March 30, 2009

Subject: Comments from the City of Palo Alto on the Hydromodification Management Plan (HMP) Applicability Map contained in the Municipal Regional Permit Revised Tentative Order

## Area of Catchment 386

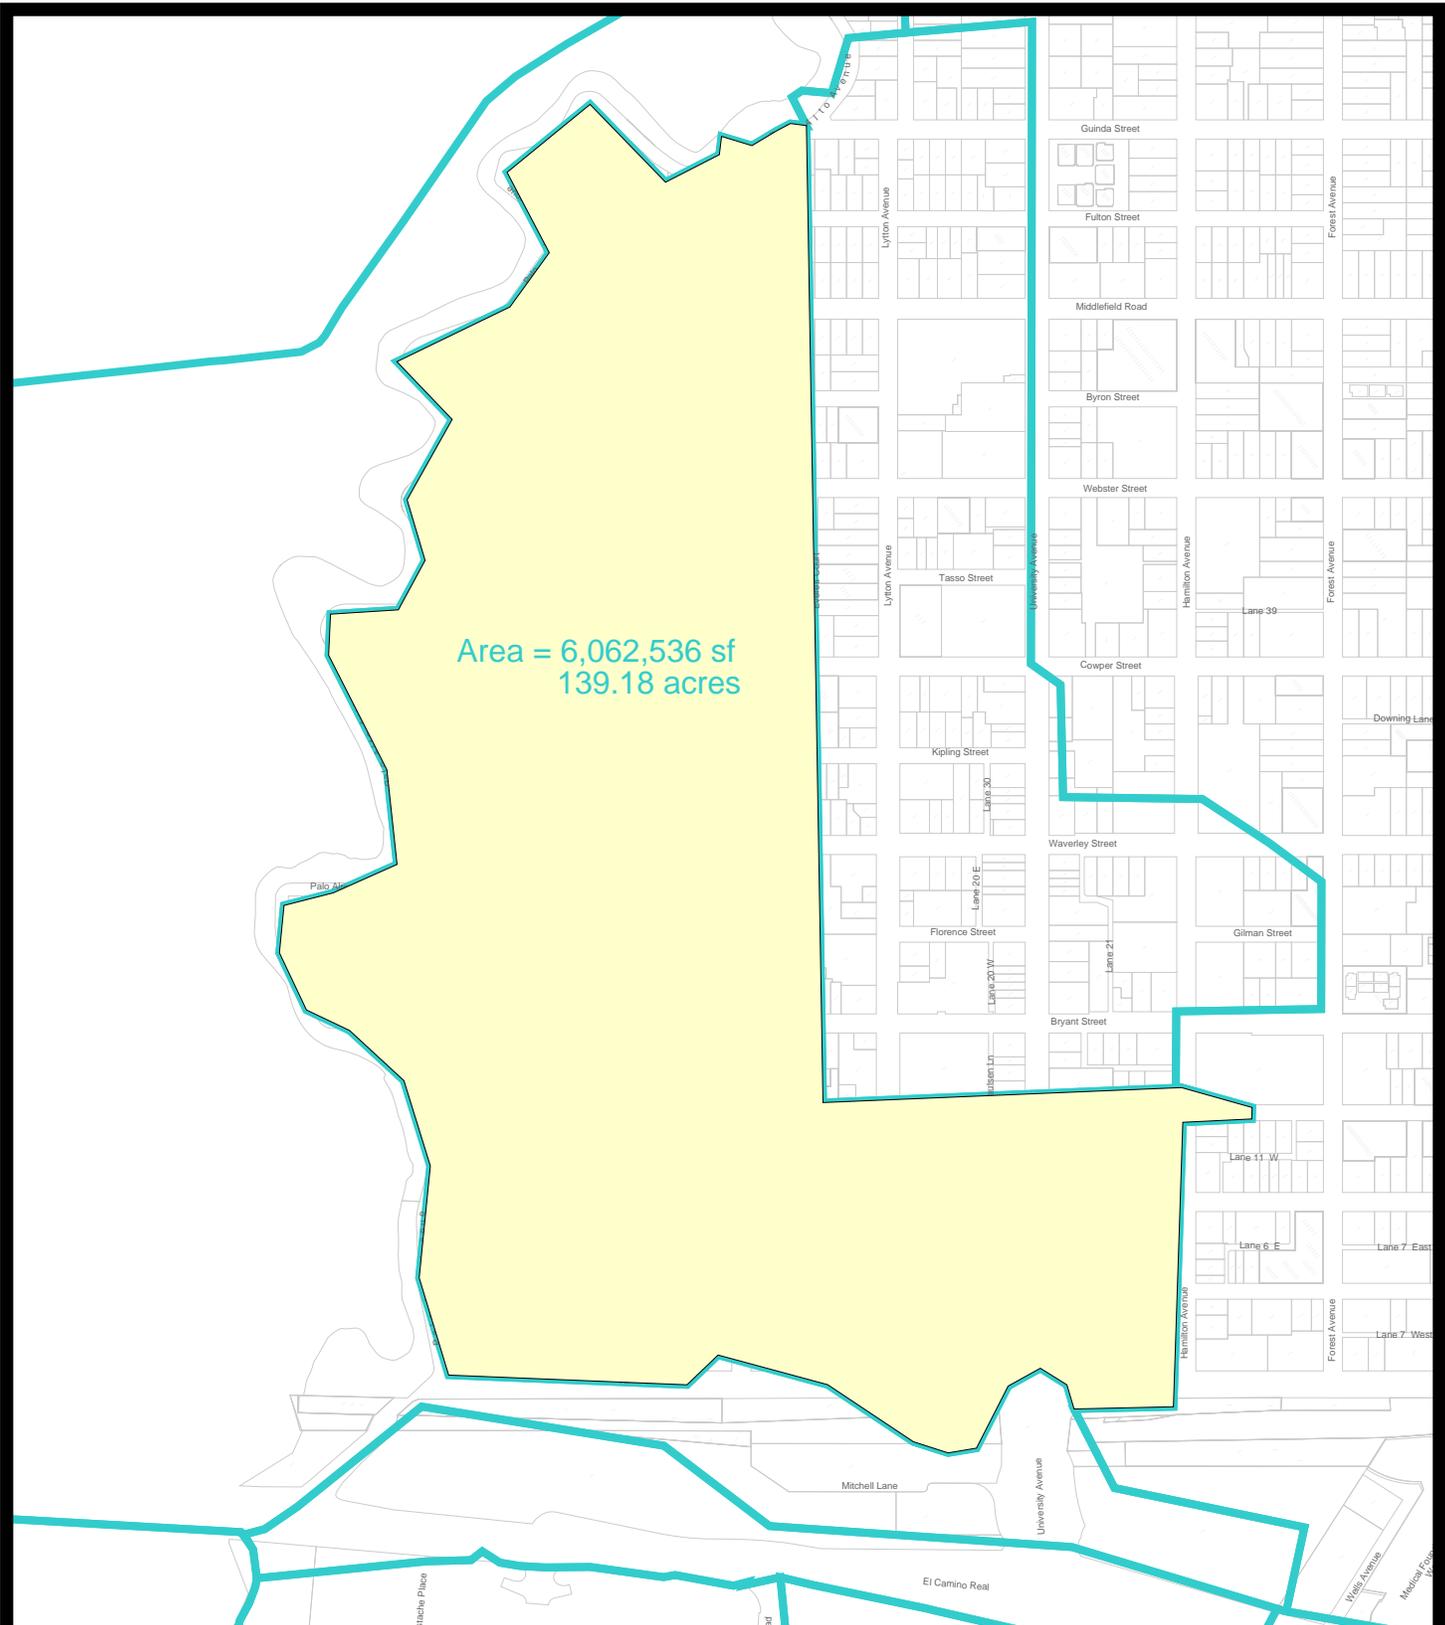
Staff used the City's billing system impervious area data and its Geographic Information System (GIS) to calculate the imperviousness of the catchment to the north of Downtown Palo Alto (see attached map). The impervious area study of this catchment yielded the following results:

PARCEL IMPERVIOUS AREA =	2598000	SQ FT
STREET/SIDEWALK IMPERVIOUS AREA =	2011633	SQ FT
TOTAL IMPERVIOUS AREA =	4609633	SQ FT
TOTAL AREA OF POLYGON =	6062536	SQ FT
PERCENT IMPERVIOUS =	<b>76.03%</b>

Based on this analysis demonstrating that the catchment immediately to the north of downtown Palo Alto is approximately 76% impervious, I hereby request that this catchment be changed to "red" (exempt) on the HMP Applicability Map to be adopted by the Water Board with the Municipal Regional Permit. If you have any questions or need further information, please contact me at (650) 329-2129 or [joe.teresi@cityofpaloalto.org](mailto:joe.teresi@cityofpaloalto.org).
